Address of the Project: **431 Pittwater Road, North Manly**

Description of Project: **Engineering Referral Response - DA2023/1708**

Image 3: 1% AEP (Combined outlet to Creek)

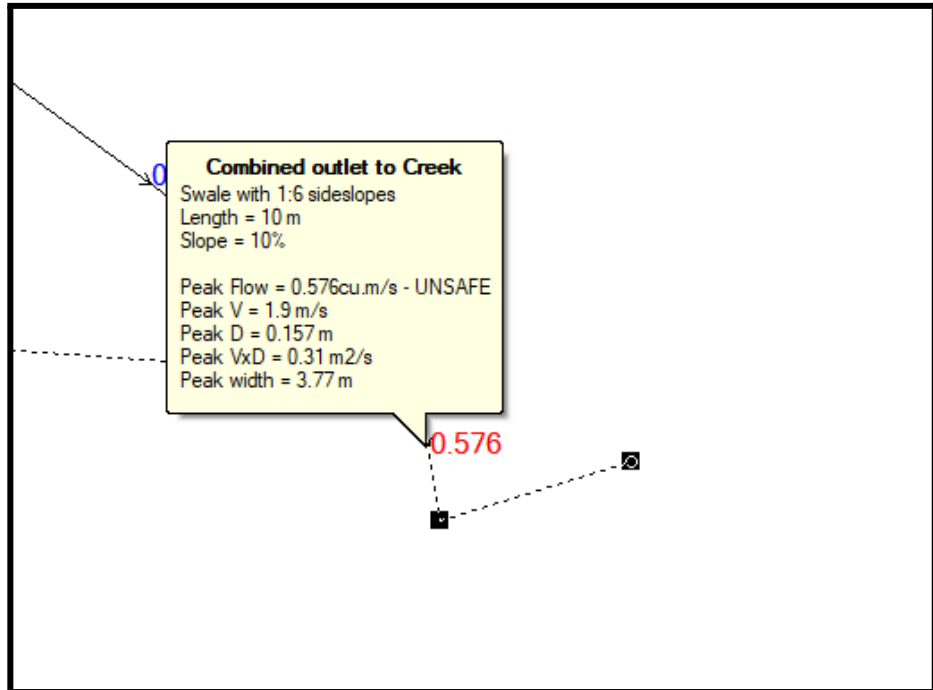
2. Flow information to confirm appropriate scour protection sizing & dimensions, including justification of the angle of the outlet connection (ideally 45 degree angle downstream)

- The Stormwater Management Plan has been updated to show both headwall outlets at a 45-degree angle to downstream flow (Refer to STORM-1/A attached).
- The use of two outlets have been used due to the unsafe outlet flows in large storm events (See image 3).

Image 6: 431 Pittwater Road - MUSIC Model

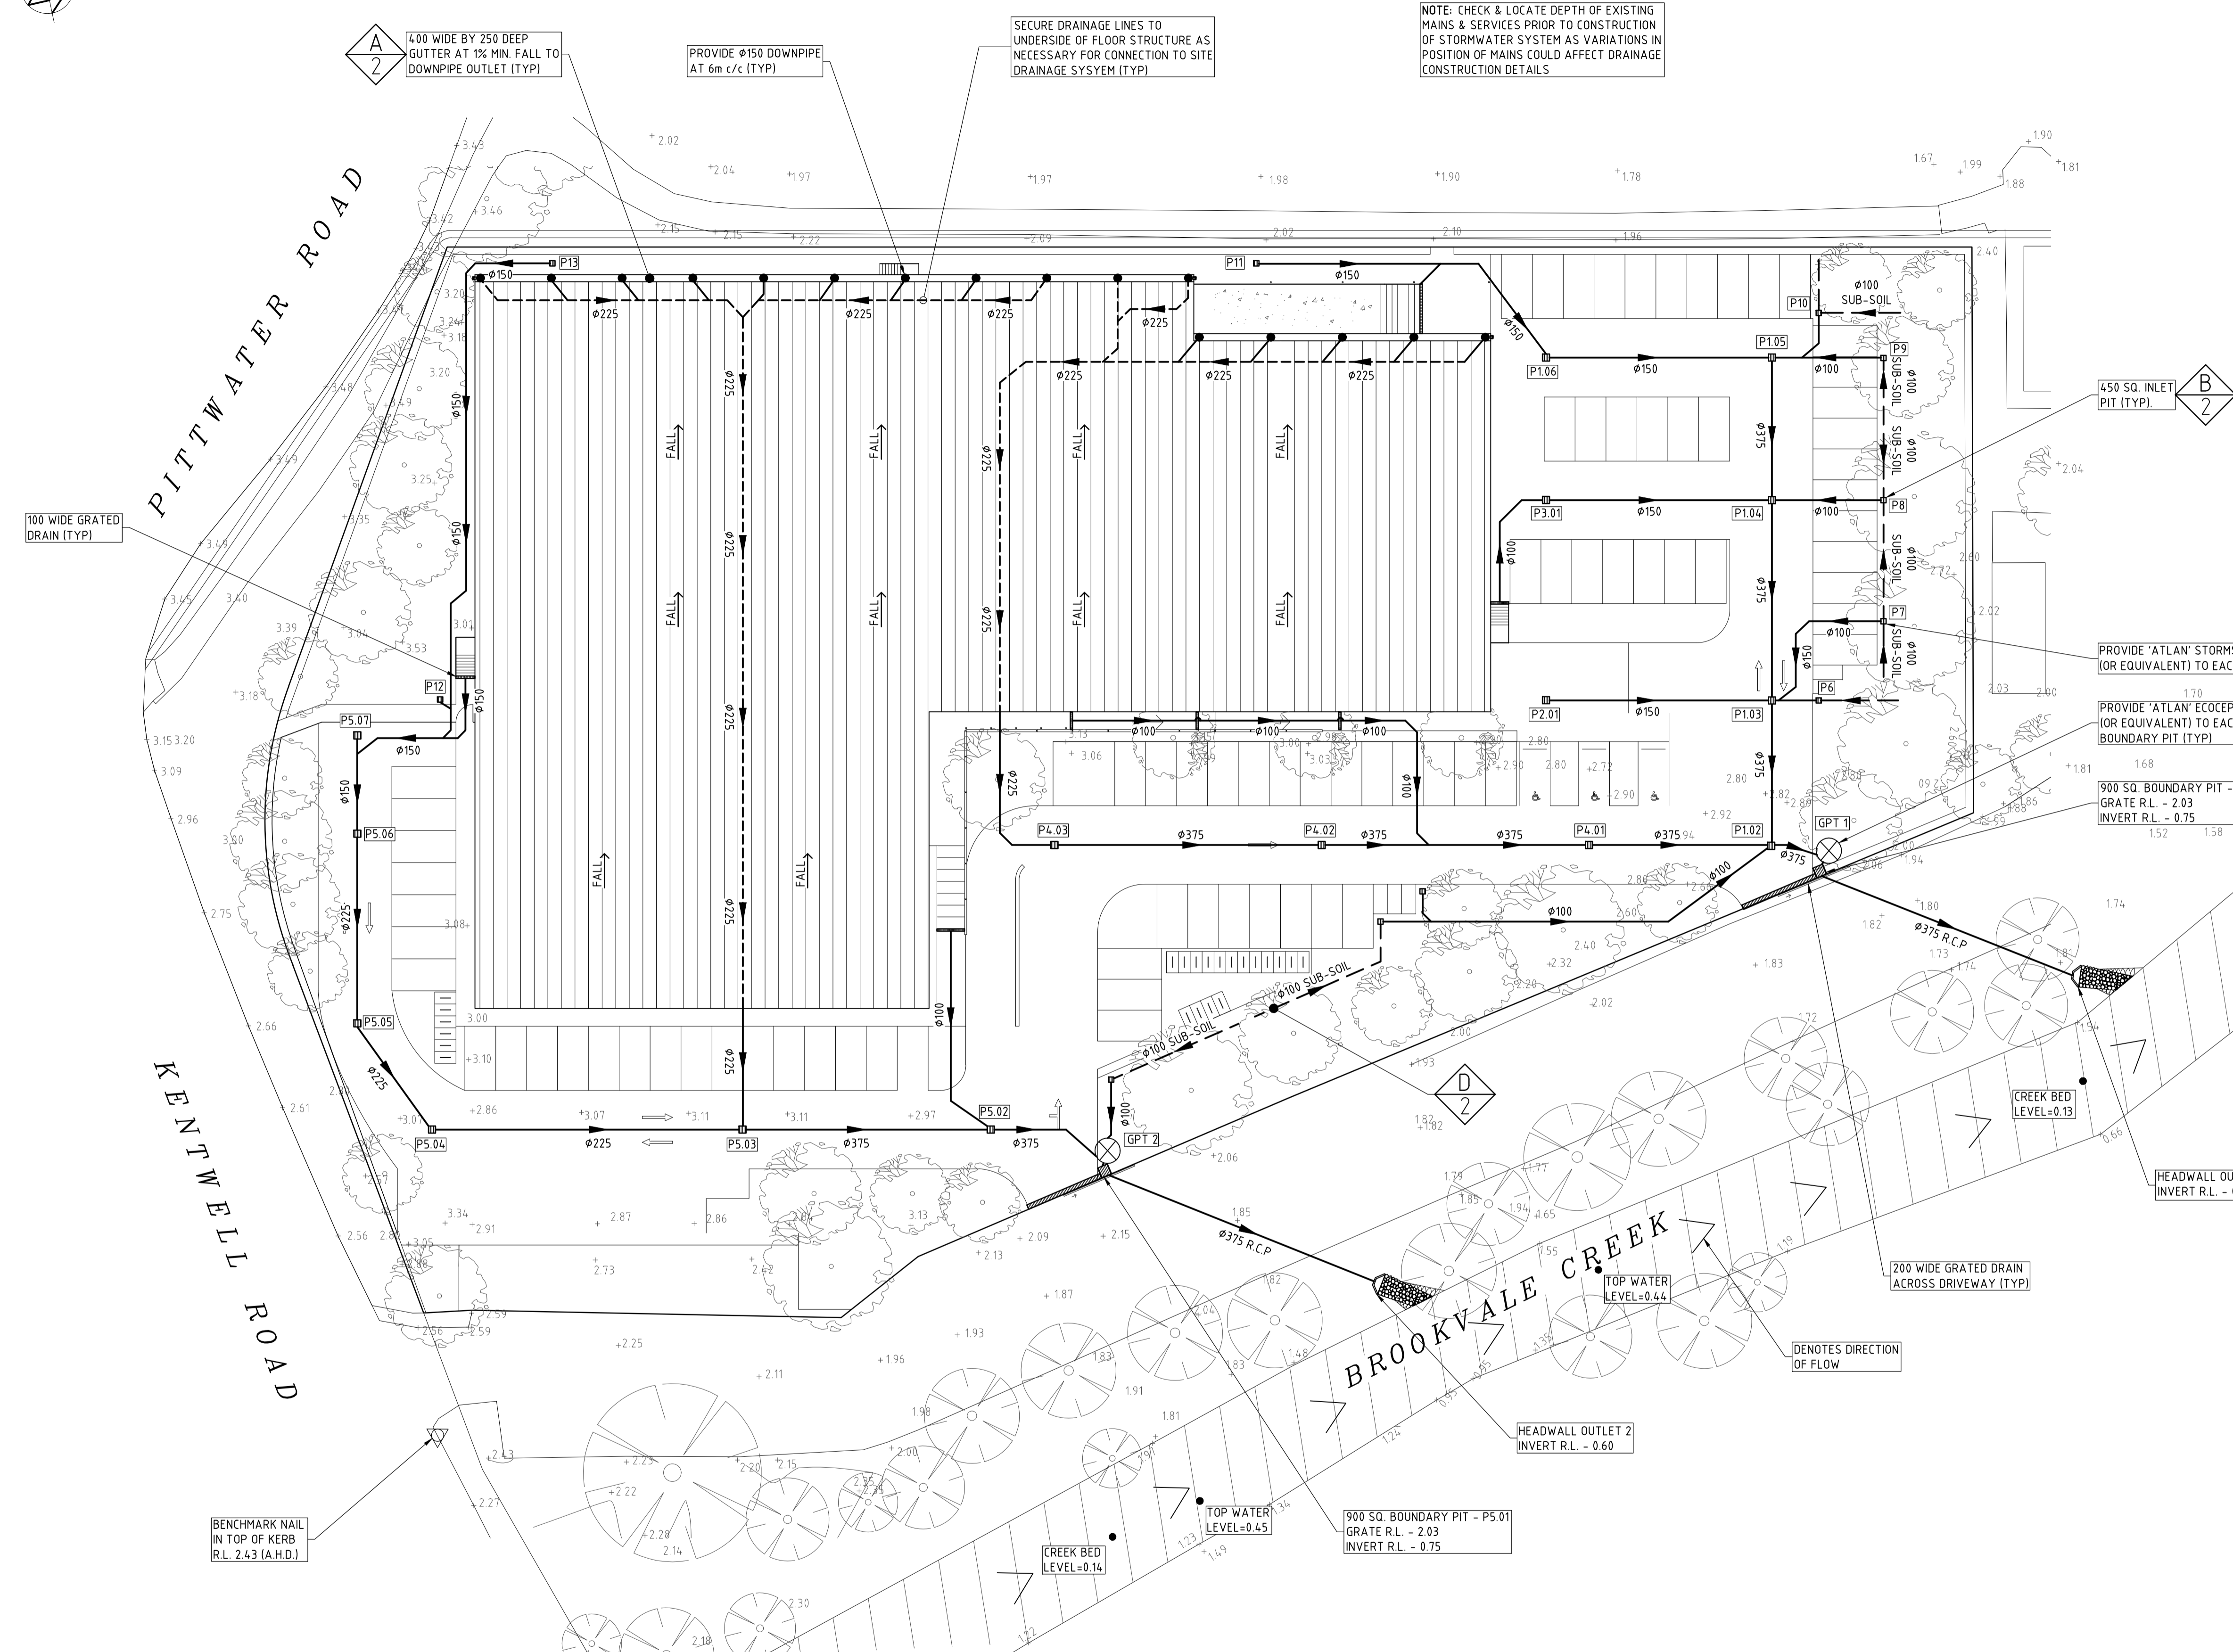
1. *Stormwater Plan is not supported by a water quality model, and the design is lacking water sensitive urban design features.*

The plan incorporates Stormsacks and Ecoceptors per Water Quality Management requirements stated in Table 5 of Northern Beaches Council Water Management for Development Policy (See MUSIC model attached). Northern Beaches Councils Stormwater quality objectives are also met through the combined use of scour protection measures and water quality management devices.

DRAWING NO. STORM-1/A

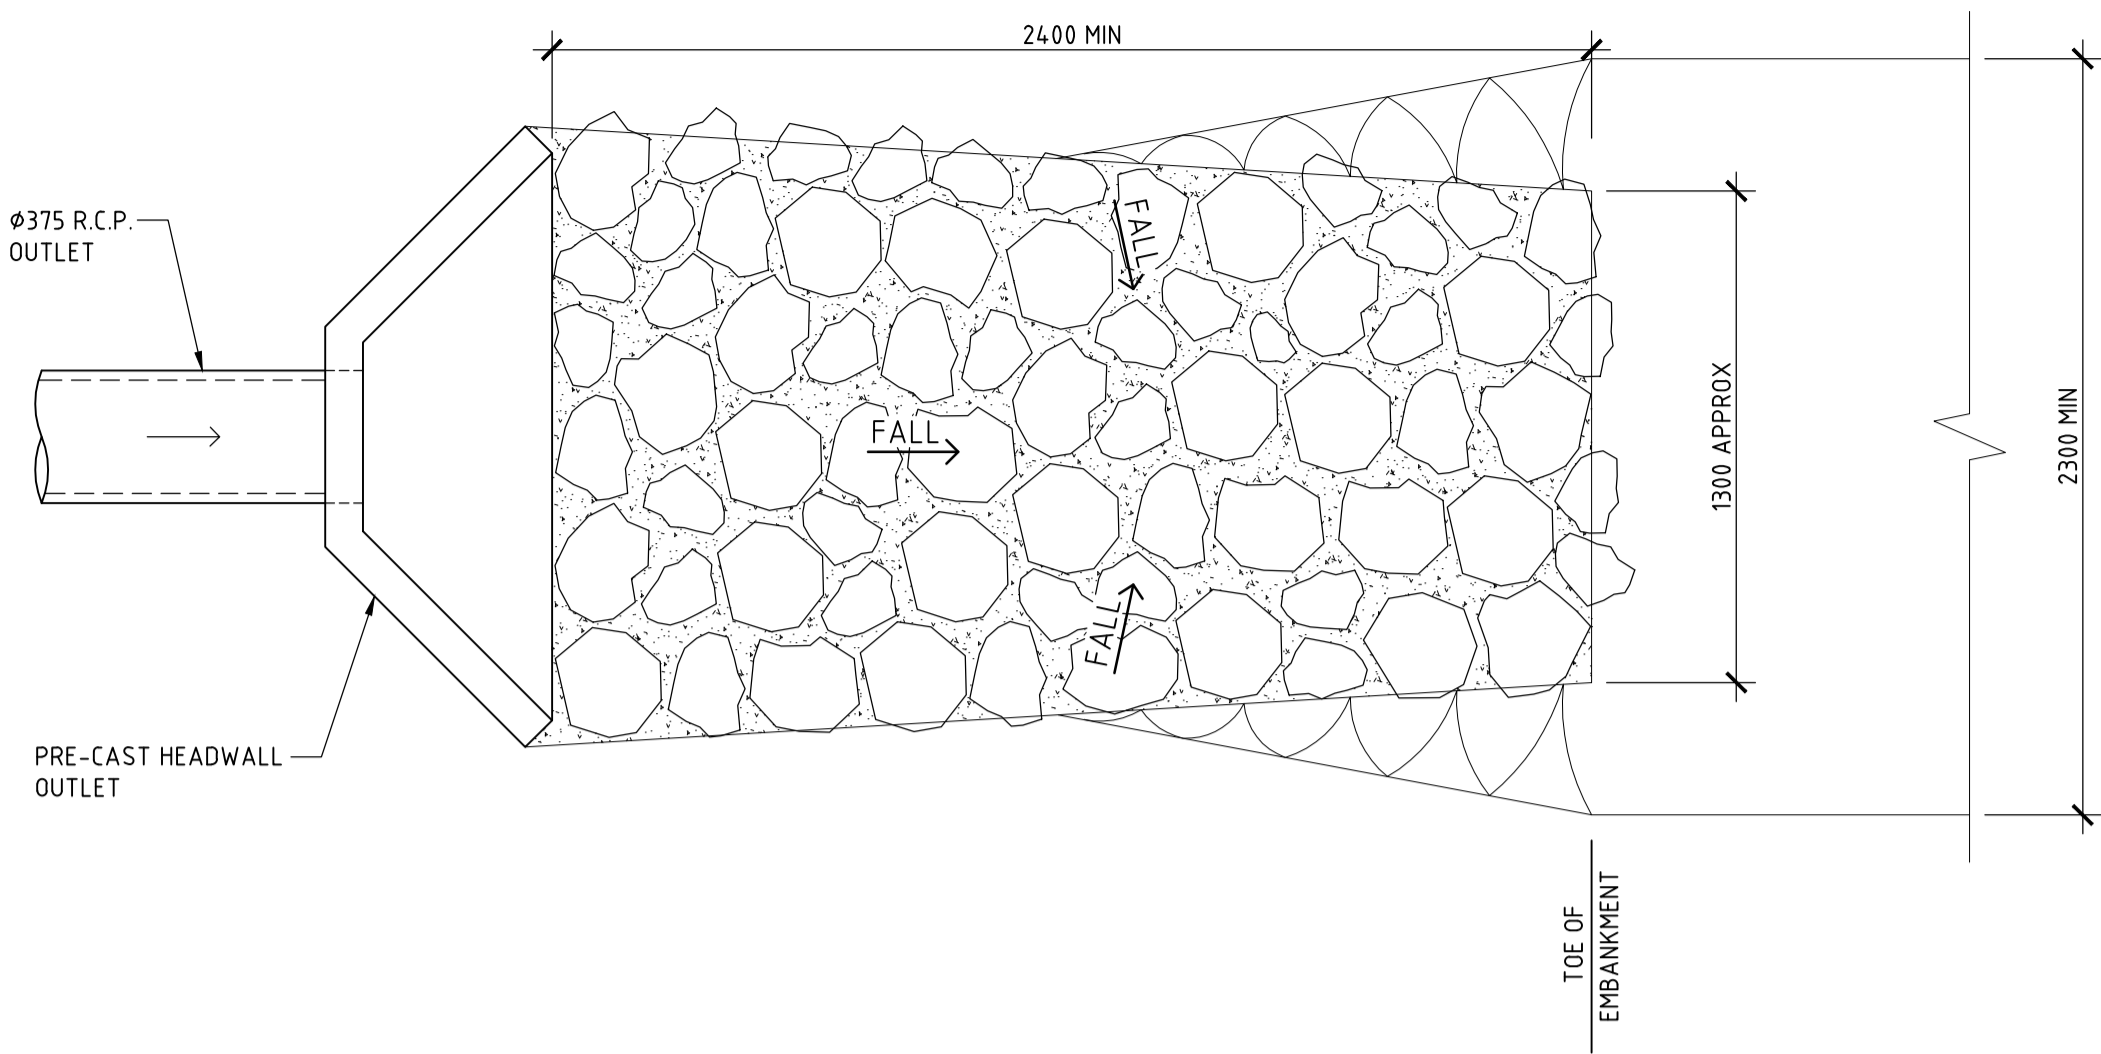
1. Outlet cross-section with relevant outlet and creek levels

- The Stormwater Management Plan has been updated with additional topographic levels to show the existing creek bed & water surface levels (Refer to STORM-1/A & STORM-2/A attached).
- Headwall outlet & scour protection detail has been updated to show proposed outlet levels (Refer to STORM-2/A attached).
